**SECOND STAKEHOLDERS WORKSHOP FOR THE
REVIEW AND UPDATING OF THE ROAD DESIGN
MANUAL & STANDARD SPECIFICATIONS FOR KENYA**

**FEEDBACK FROM THE ARCHITECTURAL
ASSOCIATION OF KENYA (AAK)**

18TH AUGUST 2023

Urban roads

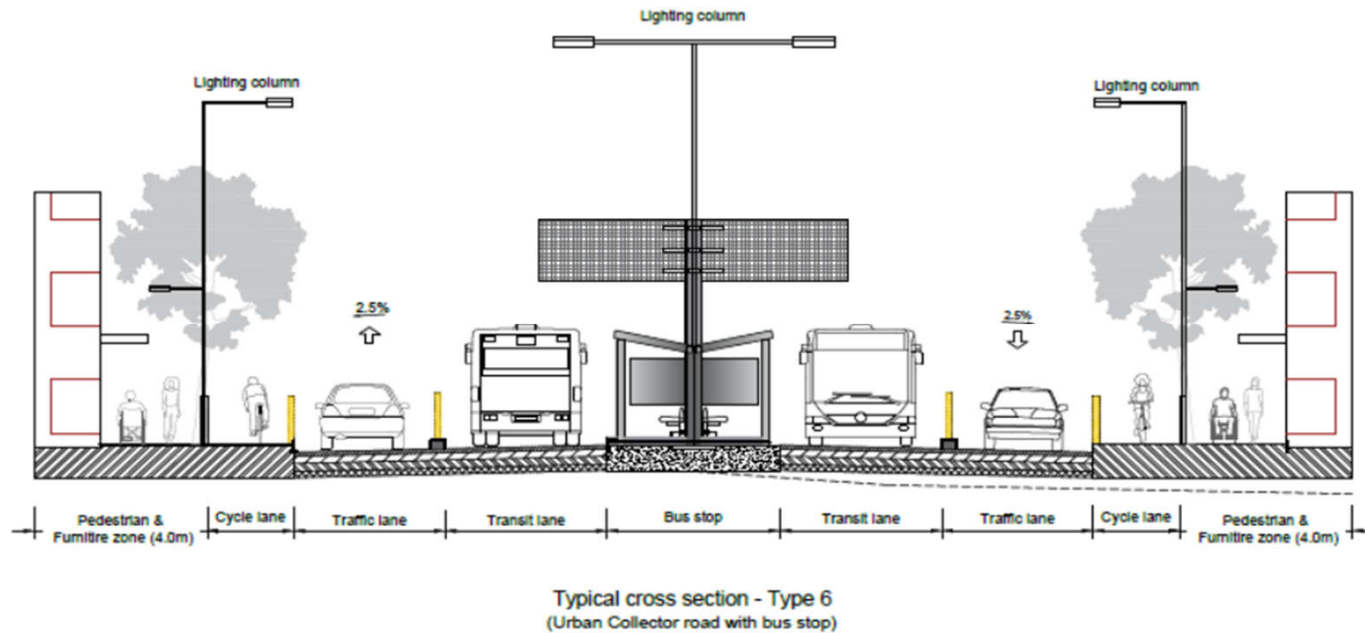
- The manual doesn't indicate minimum sizes of the cycle lanes, pedestrian and furniture zones in this cross section.
- Sufficient space of about 3m minimum width should be provided for pedestrians exclusive of the arcade

Urban roads

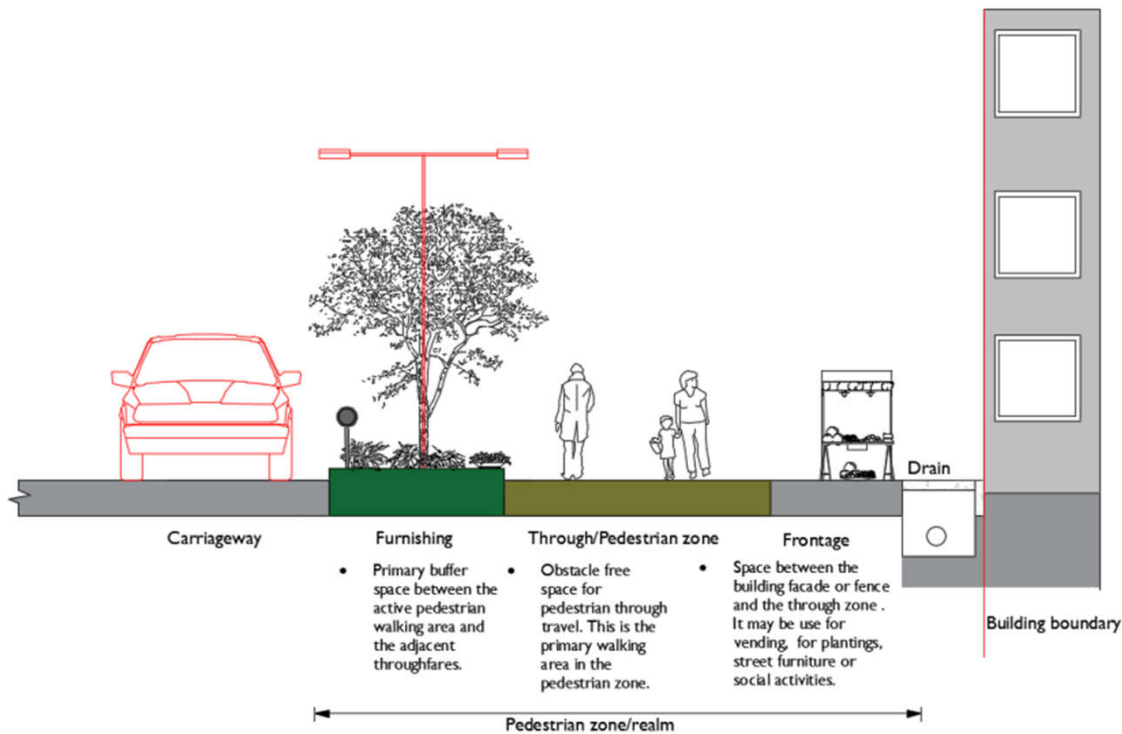
- The minimum widths of the pedestrian zone should be well indicated.
- Footpaths should be restricted to NMT users like pedestrians, people in wheelchairs. MT like motorcycles and tuktuks should not be allowed.
- The clear widths of footpaths should not be affected by kerbs, street lighting and utility posts. They should be restricted to the furniture zone

A good example on universal access

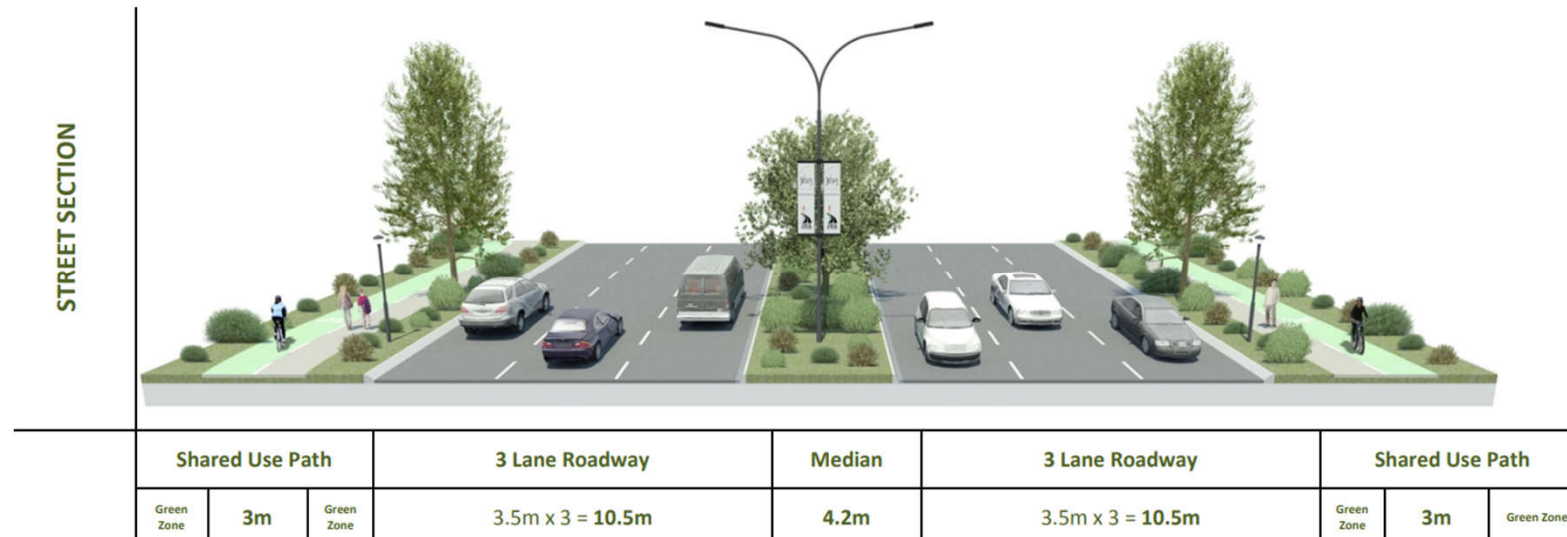
- Provide for the provision of ramps not more than 6% at obstructions that occur like at kerb raised medians, channeling islands and property accesses for universal access.
- A footpath with a minimum clear width of 2m should be provided after the ramp
